### **REMARKS**

**AMENDMENTS TO THE DRAWINGS**

The attached sheets of drawings includes changes to Figures 2, 4, 6, 7, and 11. These sheets replace the original sheets for Figure 2, 4, 6, 7, and 11.

FIG. 2

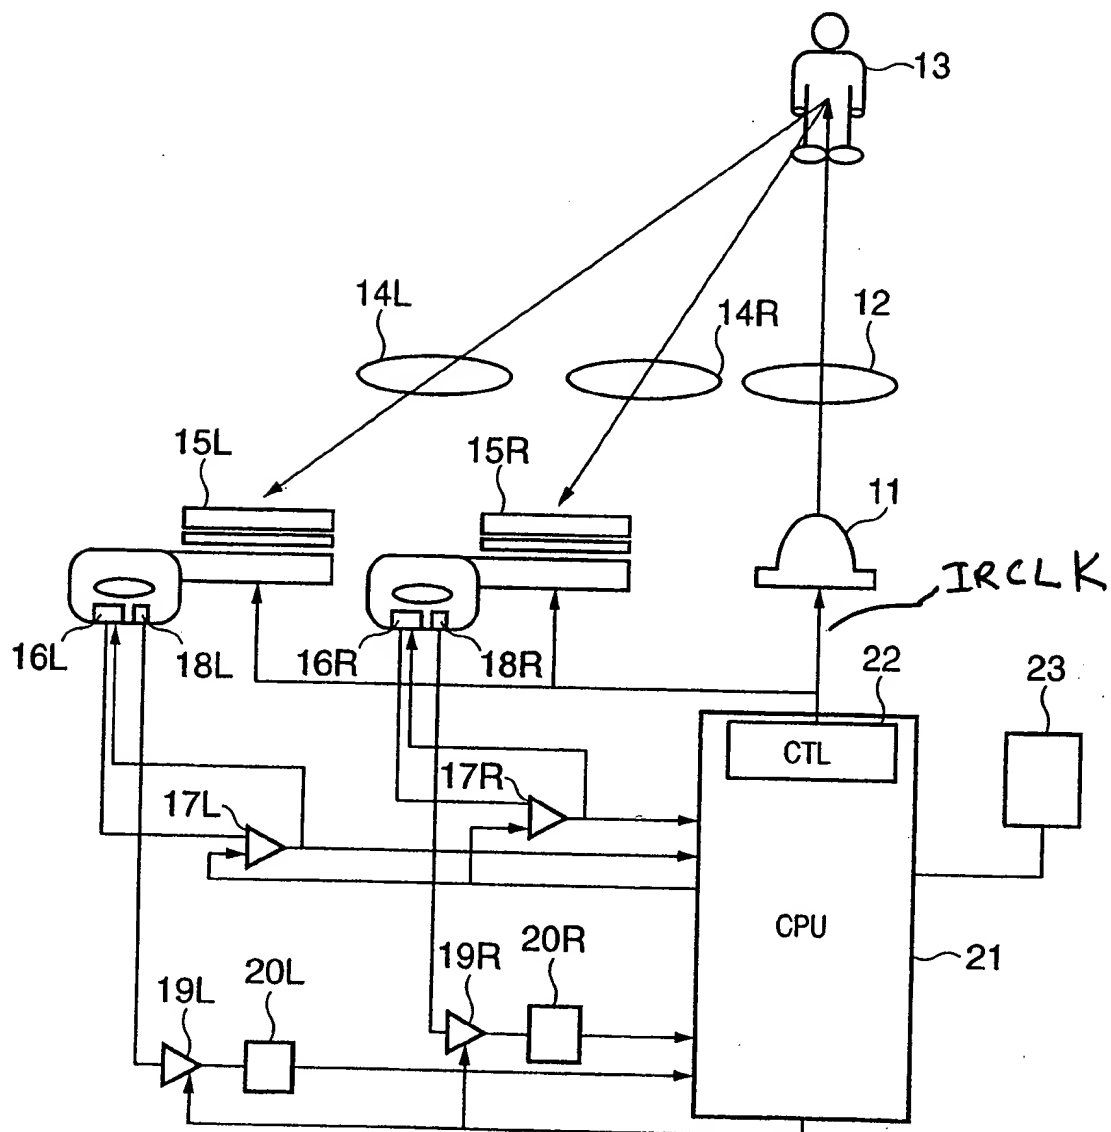
The Office Action objects to the drawings of the application, stating that they fail to comply with 37 C.F.R. §1.84(p)(5) because (1) the drawings do not include the reference sign “IRCLK” mentioned in the description; and (2) the drawings include the following reference character(s) not mentioned in the description: ST1, ST2, SH, CCDCLR, 49, 17, 18, and 19.<sup>1</sup> (3) there are references to 19L, 19R, 18L, 18R, 17L, and 17R, but there is no generic description of 17-19 (4) Figure 11 should be designated with the legend “Prior Art” because only that which is old is illustrated.

In response, Applicant has amended Figure 2 to show the reference sign “IRCLK”. Applicant has also amended Figure 4 to remove the reference to “ST1, ST2, SH, CCDCLR, 49, 17, 18, and 19.”

In the case of Figure 2, the reference sign “IRCLK” has been added. The reference sign “IRCLK” refers to the vertical arrow that connects reference numeral 22 with 11 in Figure 2.

FIG. 4

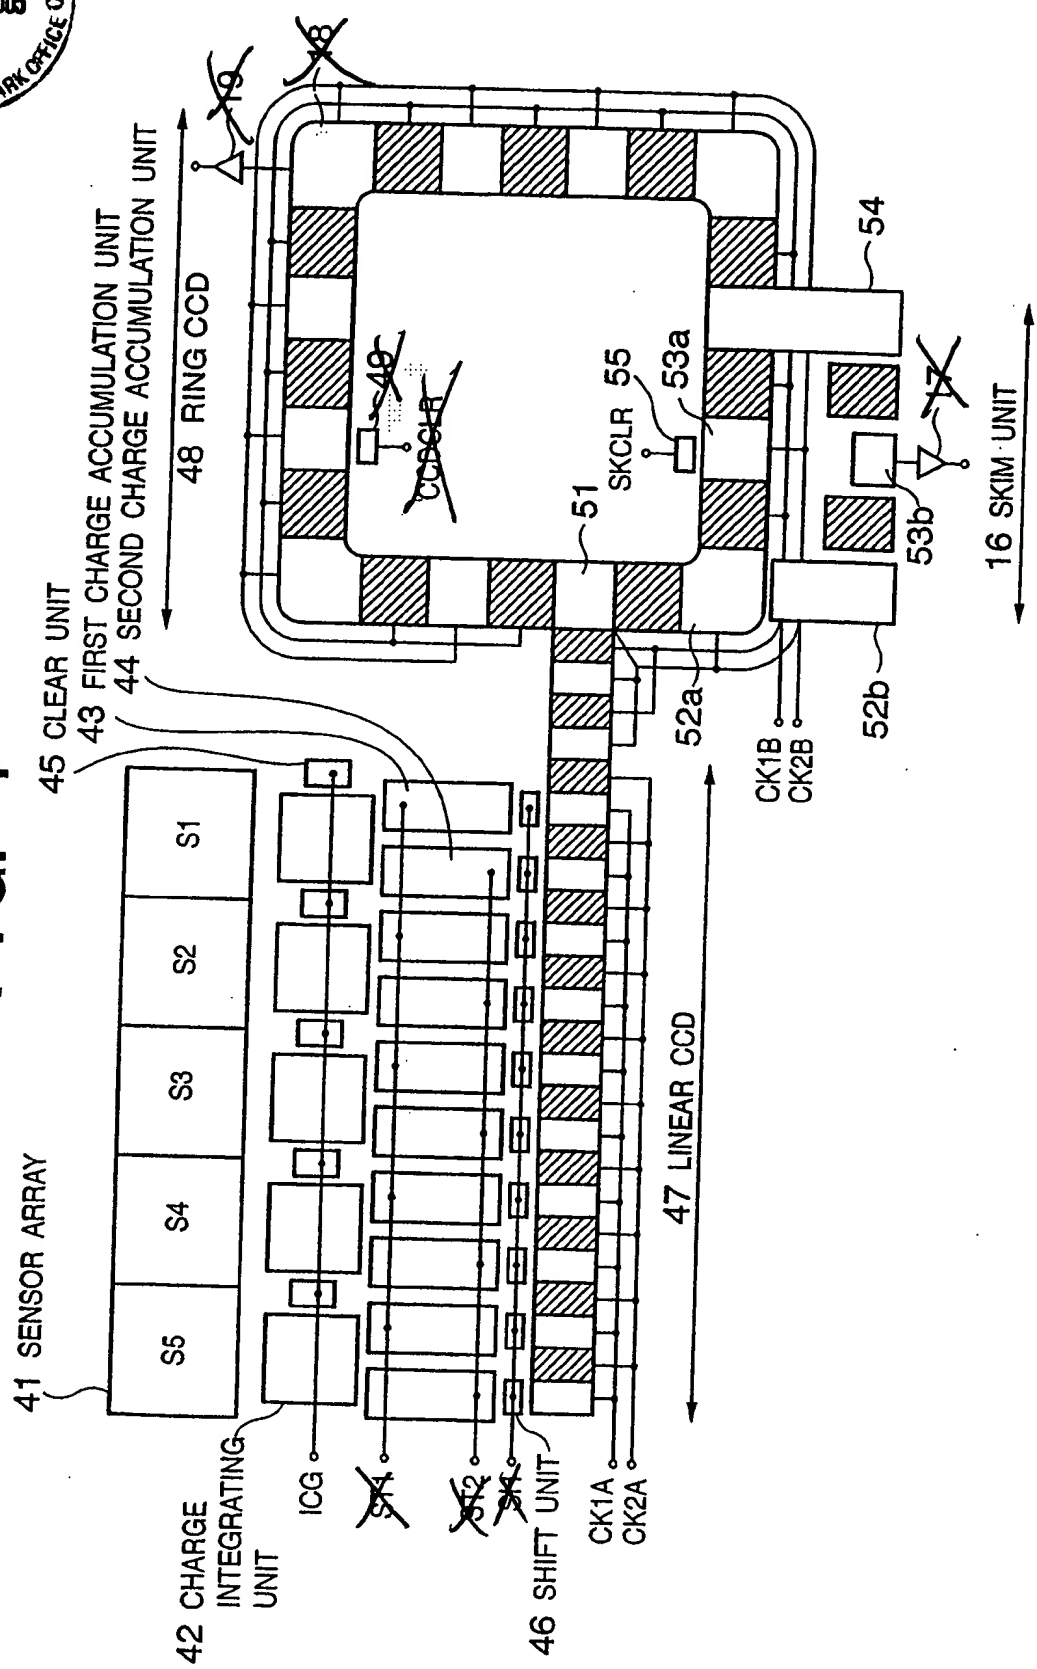
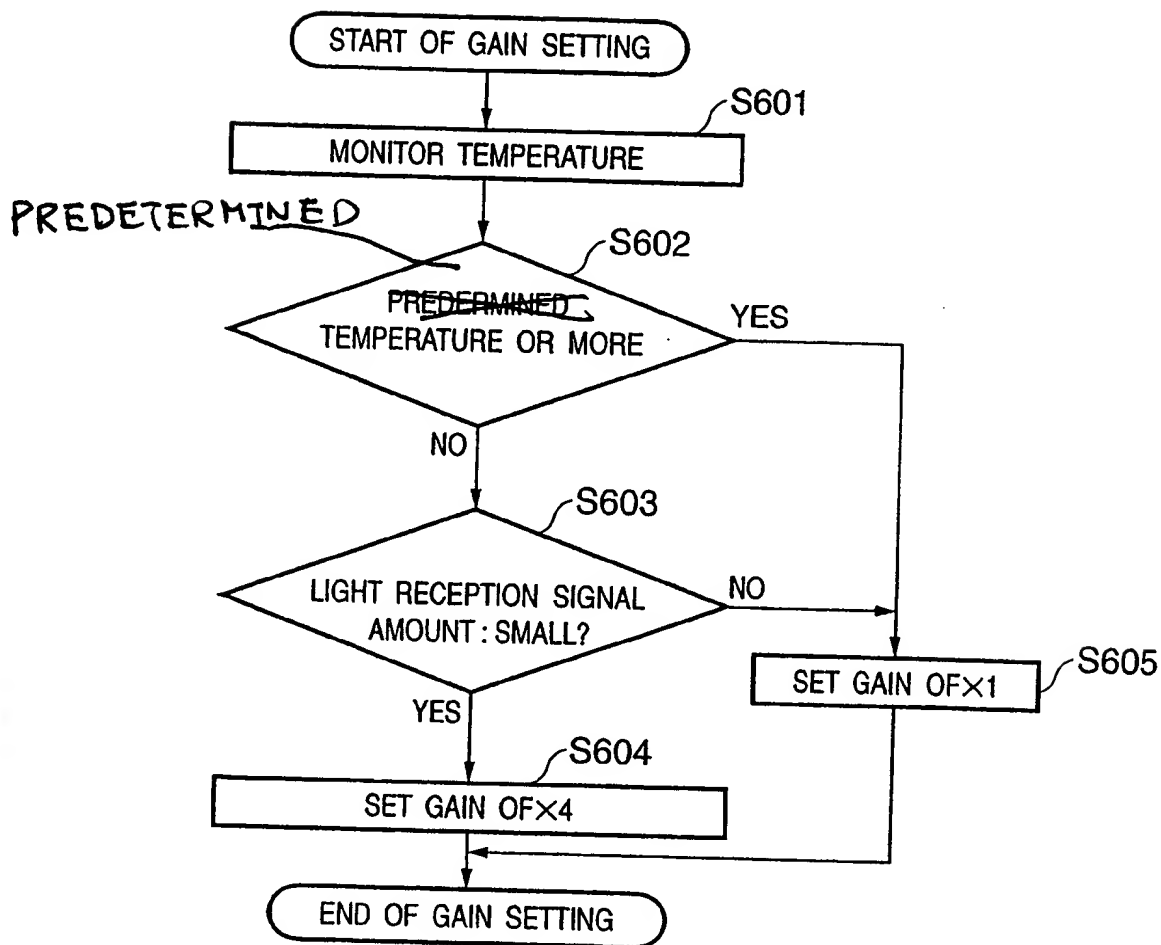
<sup>1</sup> Applicant notes that the Office Action alleges that the terms “ST1, ST2, SH, CCDCLR, 49, 17, 18, and 19” are not found in Figure 14. Applicant, however, notes that there are only 11 figures in this application. It is Applicant’s understanding that the objection was to Figure 4, not 14. Applicant respectfully requests Examiner to inform Applicant if Applicant’s understanding is not correct.

In Figure 4, the reference signs “ST1”, “ST2”, “SH”, “CCDCLR”, “49”, “17”, “18”, and “19” have been deleted.

FIG. 6

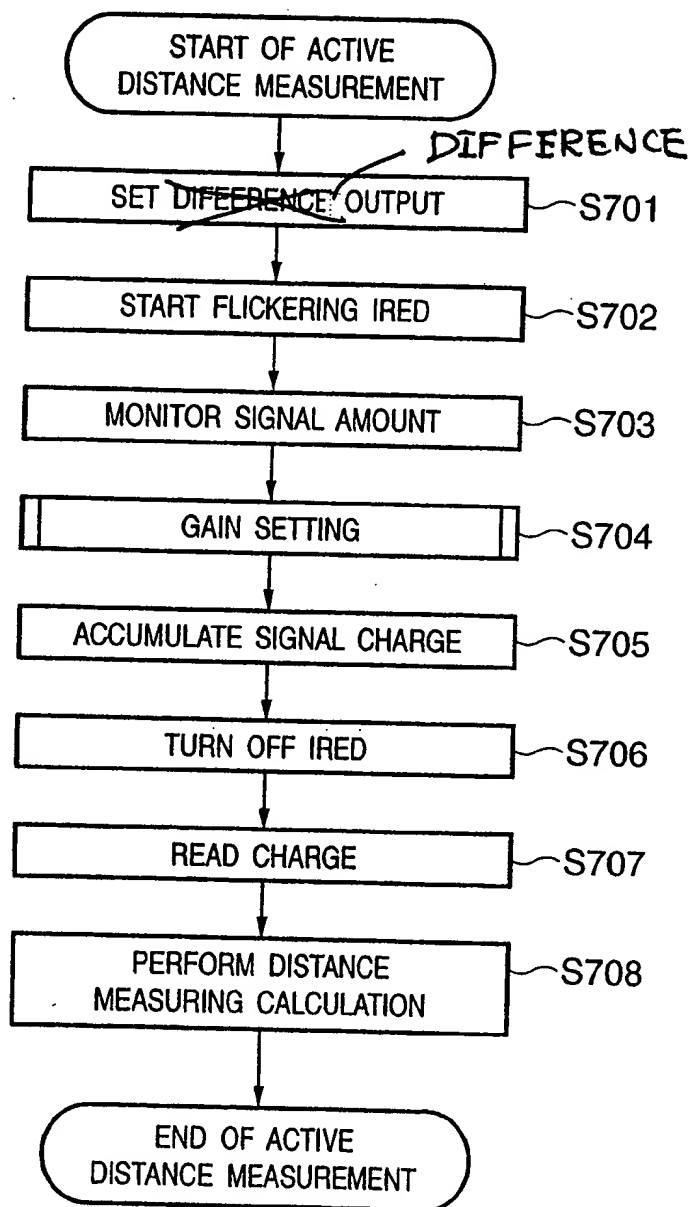
Additionally, Applicant has amended Figures 6 and 7 to correct minor typographical errors. In Figure 6, step S602 has been amended to read “PREDETERMINED TEMPERATURE OR MORE”, while in Figure 7, step S701 has been amended to read “SET DIFFERENCE OUTPUT”.

In Figure 6, step S602 has been amended to read “PREDETERMINED TEMPERATURE OR MORE”.
